**SUBJECT: Wireless Telecommunications Facility Permit Application
(T-Mobile Site # LA33664E)**

SECOND NOTICE OF INCOMPLETENESS

Subject: Second Screencheck Comments - Wireless Telecommunication Facility Permit T-Mobile Site #LA33664E; W/O 10876 Culver Blvd

**ATTACHMENT 1
SECOND SCREENCHECK COMMENTS
WIRELESS TELECOMMUNICATION FACILITY PERMIT
T-MOBILE SITE #LA33664E – W/O 10876 CULVER BLVD**

SITE PLAN
SCALE 1" = 20'
0 10 20 30
50'

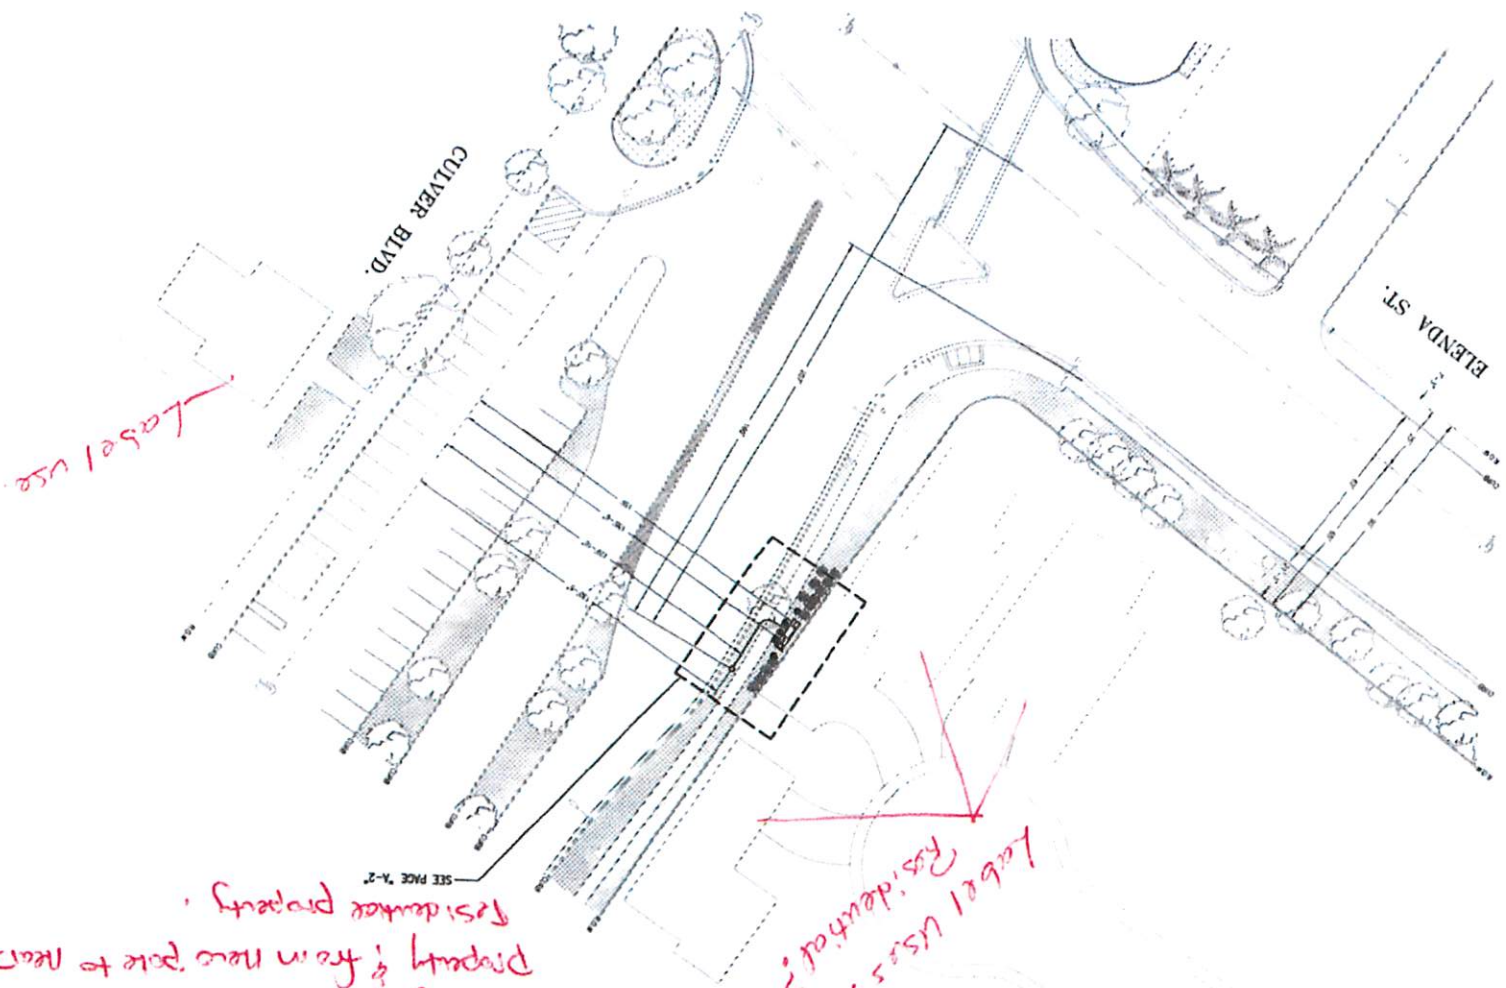
16. *2nd Request.* Label surrounding buildings and land uses. See redlined plans.

17. Show setback dimensions from the ground equipment to the nearest residential property and from the new pole to the nearest residential property. See redlined plans.

Dimension distance
from equipment to nearest residential
property & from new pole to nearest
residential property.

SHEET TITLE:
SITE PLAN
AND DETAILS
SHEET NUMBER:
A-1

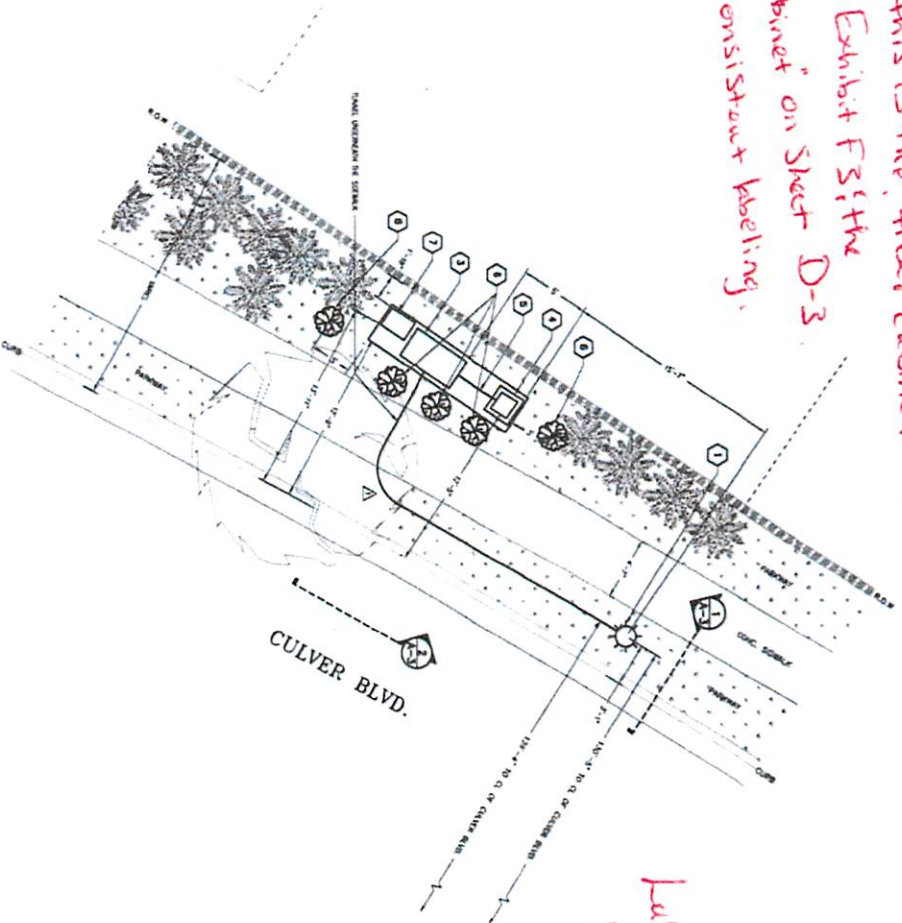
18. Label all existing utilities. See redlined plans.

19. Clarify if note #7 in the Placement and Construction Data section is referring to the same equipment as that which is referred to as the “fiber cabinet” shown on Exhibit F3 and the “boxer cabinet” shown on Sheet D-3 of the engineering plans. If so, provide consistent labeling in all exhibits.

Clarify if this is the "fiber cabinet" labeled in Exhibit F3; the "Boxer cabinet" on Sheet D-3. Provide consistent labeling.

Label any existing utilities.

SHEET TITLE:
 SITE PLAN
 AND DETAILS
 SHEET NUMBER:
 A-2

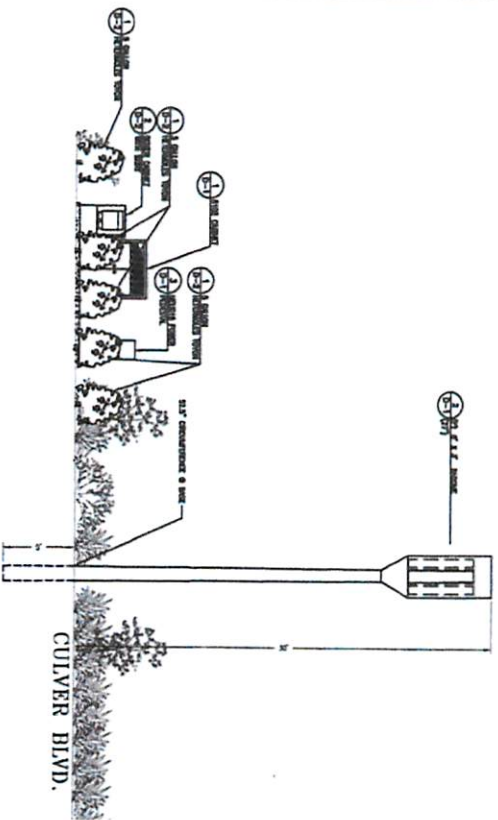
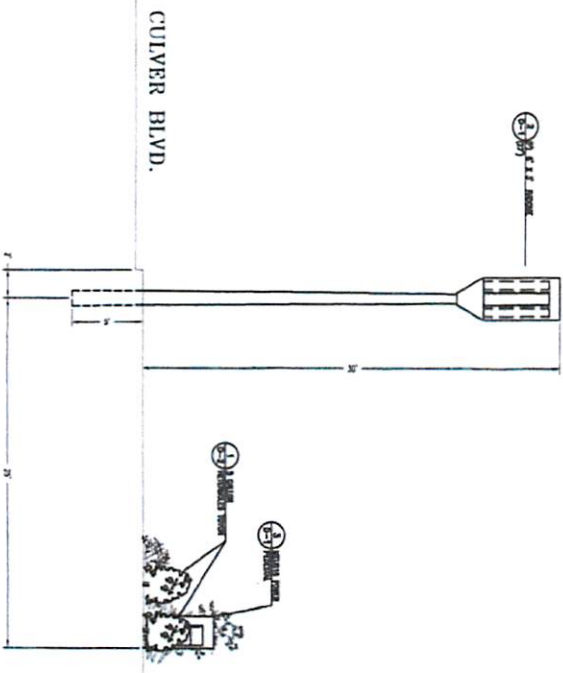
20. *2nd Request.* Add a note to the plans specifying the color of the pole. The pole shall be a neutral, non-glossy color.

21. Add a note indicating that the ground mounted equipment will be painted to match landscaping color. See redlined plans.

22. *2nd Request.* Provide a slimmer radome/shroud that is more in scale with the pole. As proposed, the large size of the radome/shroud is aesthetically displeasing and visually obtrusive.

• Add note that ground mounted equipment landscaping color.
• Specify color of pole, ~~thru~~

1 NEW CONCRETE PAD DETAILS

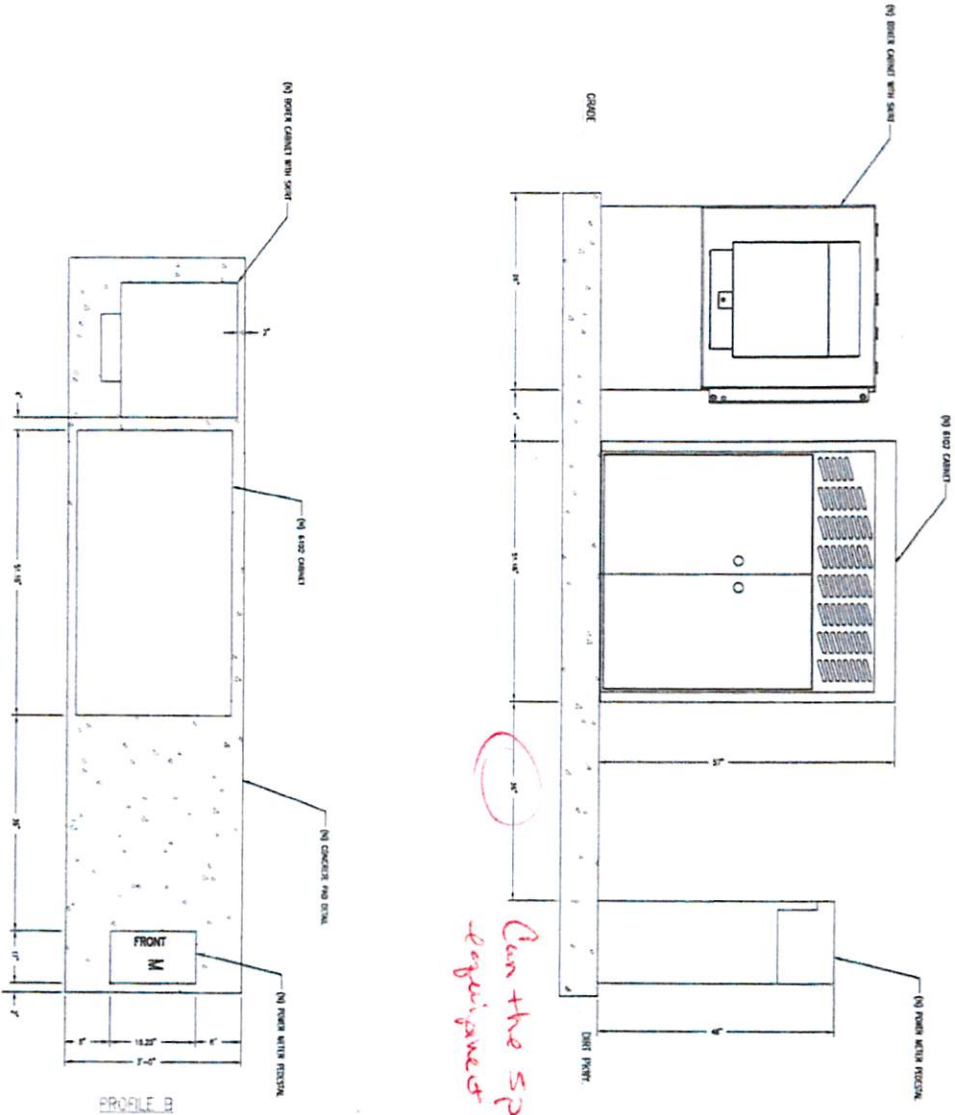
23. *2nd Request.* Decrease the size of the concrete pad to minimize the impact to the landscaped parkway. Provide clarification on why there needs to be so much space between the cabinet and the meter pedestal. See redlined plans.

*Can the space between
equipment be minimized?*
